Connecticut Yankee Atomic Power Company

Notice of Receipt of Plant Procedure **License Termination Plan (LTP)**

Change No.: 05-01

Haddam Neck Plant License Termination Plan
Distribution of Revision 2A, January 2005
Insert Instruction for Revision 2A of the HNP LTP
Memo RACY-05-017

<i>Figure Number</i>	<i>Rev</i>
Figure 5-3	0

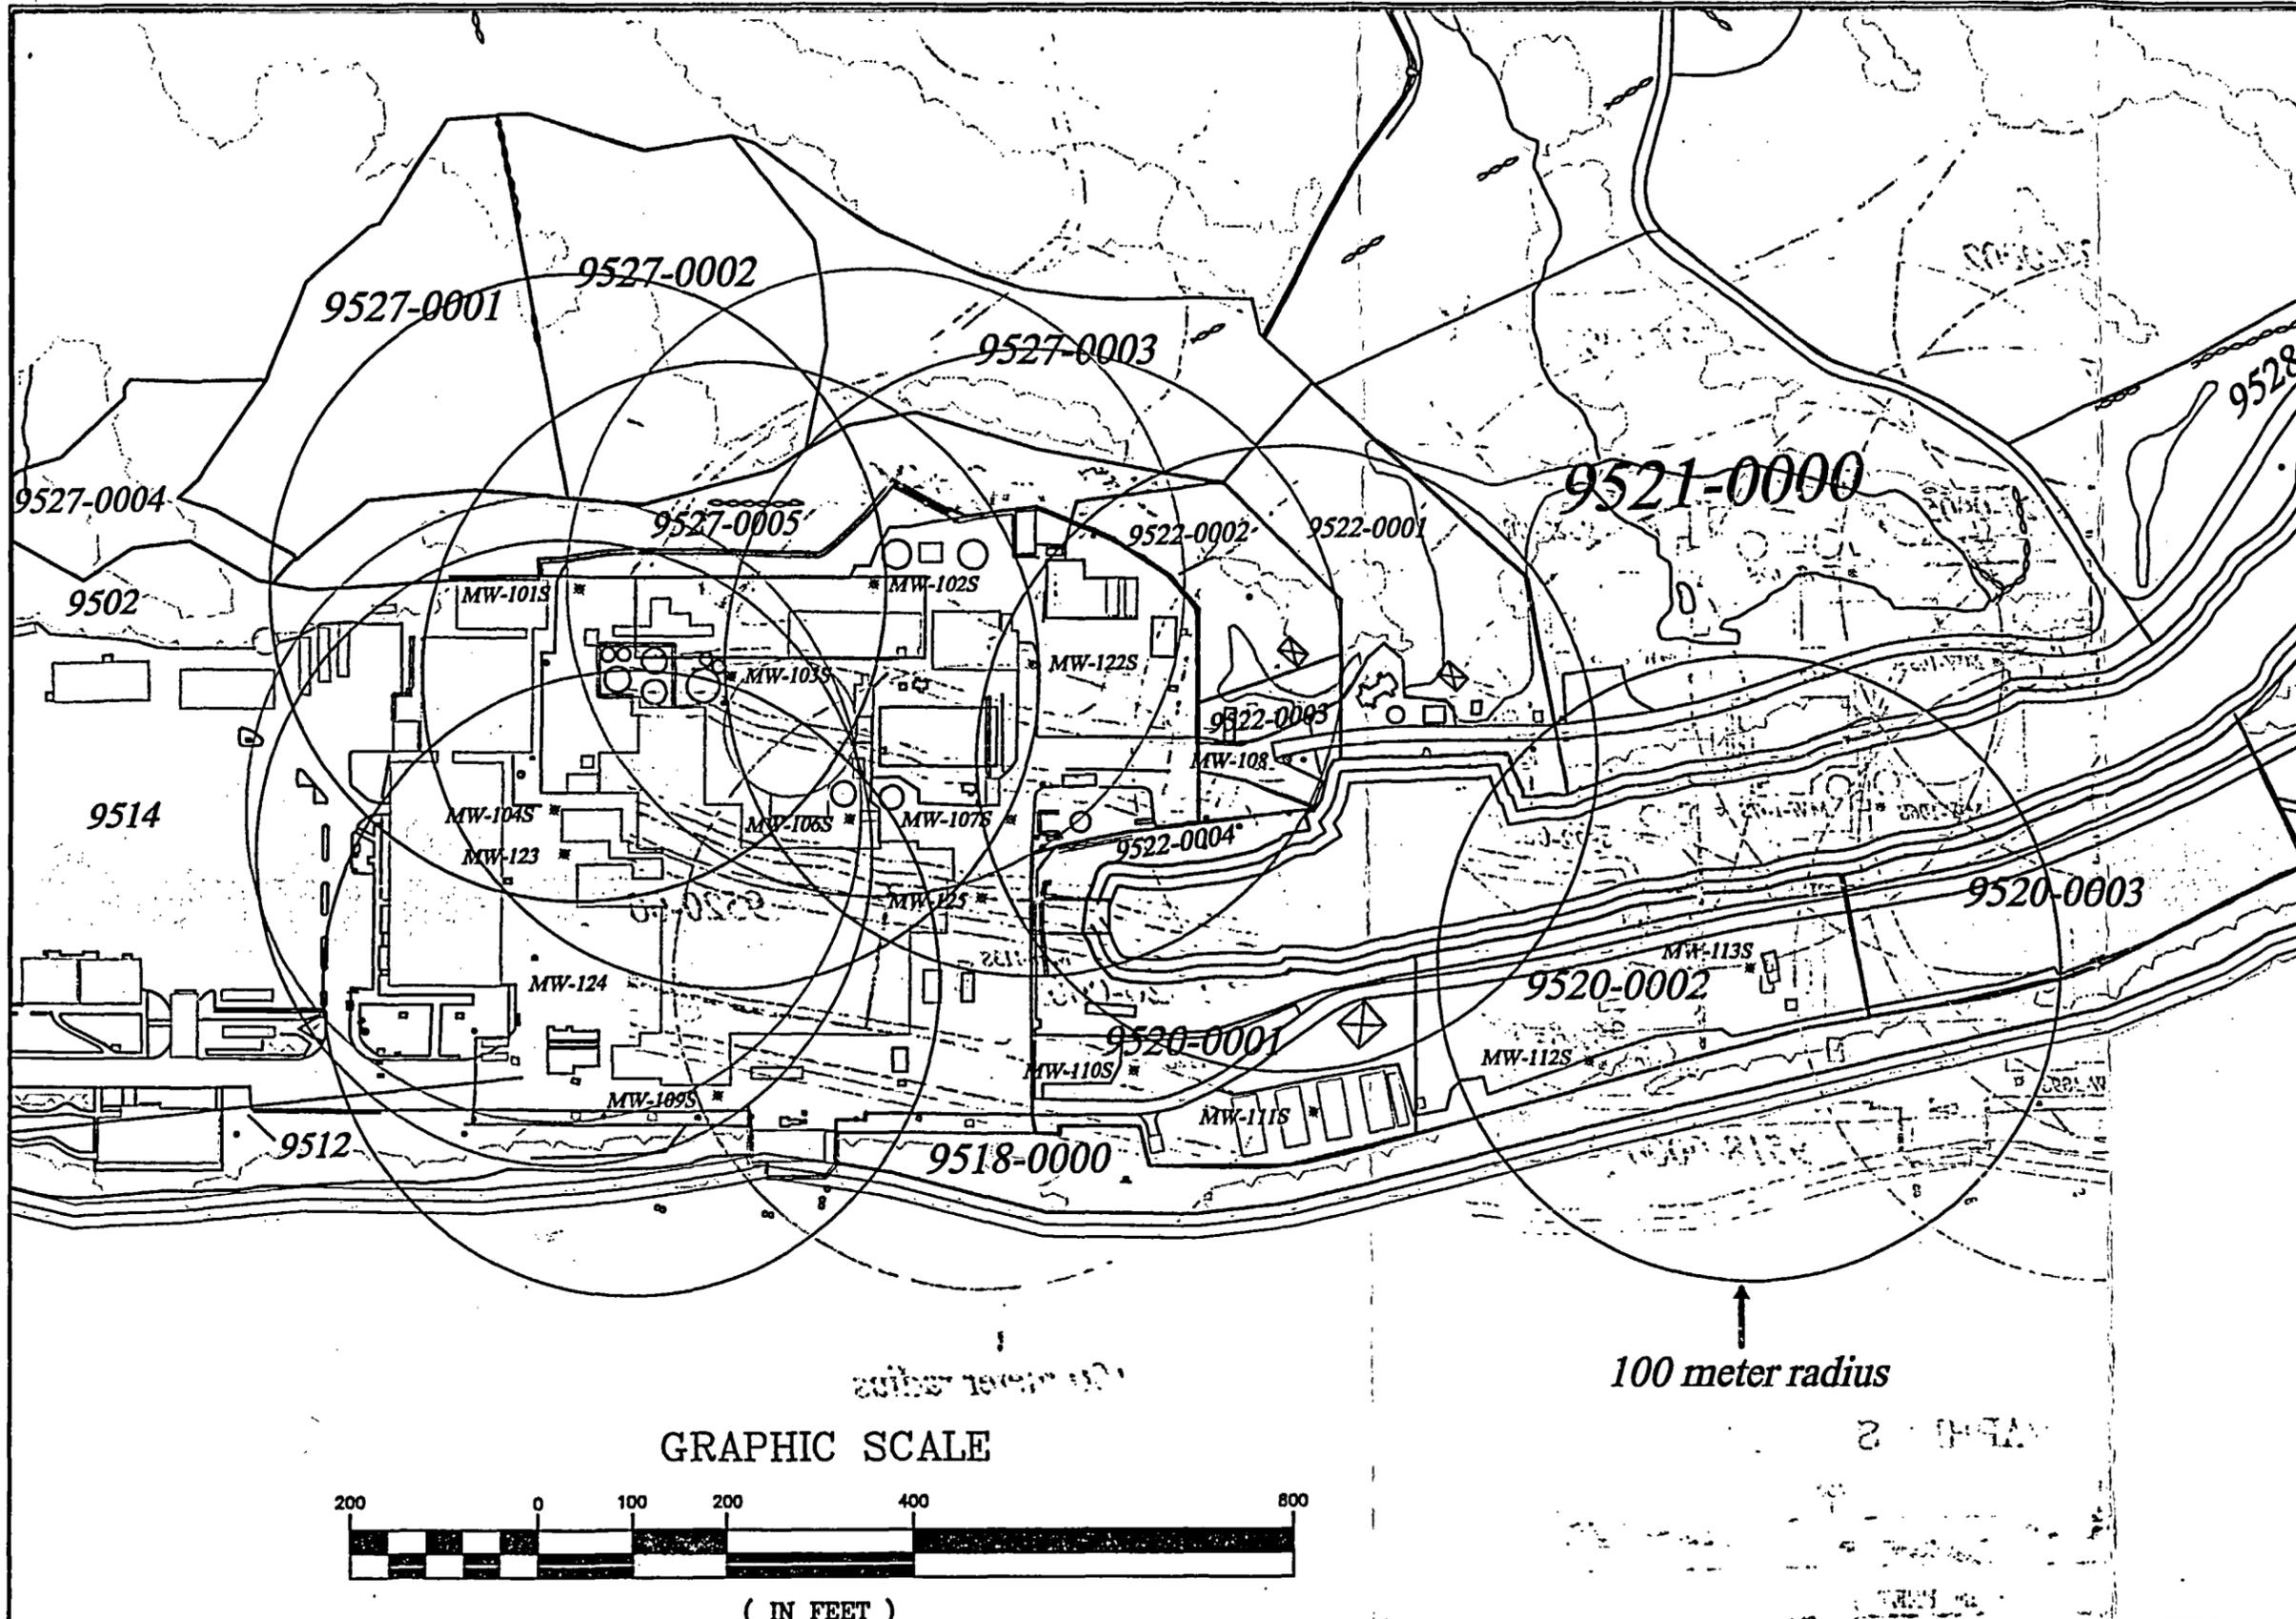
Remove Page(s)	Effective Date	Insert Page(s)	Effective Date
Table of contents Page xi	August 2004	Table of Contents Page xi	January 2005
List of Effective Pages, LEP-1 through LEP-4	August 2004	List of Effective Pages, LEP-1 through LEP-4	January 2005
3-1	August 2004	3-1	January 2005
5-12	August 2004	5-12	January 2005
5-14 through 5-16	August 2004	5-14 through 5-16	January 2005
5-65 and 5-66	August 2004	5-65 and 5-66	January 2005
5-70	August 2004	5-70	January 2005
Figure 5-3 (Old)	Rev 1	New Figure 5-3	Rev 0
None		Insert Figure 5.3-1 after figure 5-3	Rev 0

capture zone analysis determined a maximum zone of influence of 100 meters around a groundwater monitoring well, (see Figure 5-3 and 5-3.1) and reference 5-13, Estimated Zone of Influence/Capture Zone for Hypothetical Water Supply Wells in Post-Closure Dose Modeling, CH2MHILL, Technical Memorandum, dated January 11, 2005. These figures depict the capture zone around the wells which have shown detectable contamination at the perimeter of the industrial area and around peninsula wells.
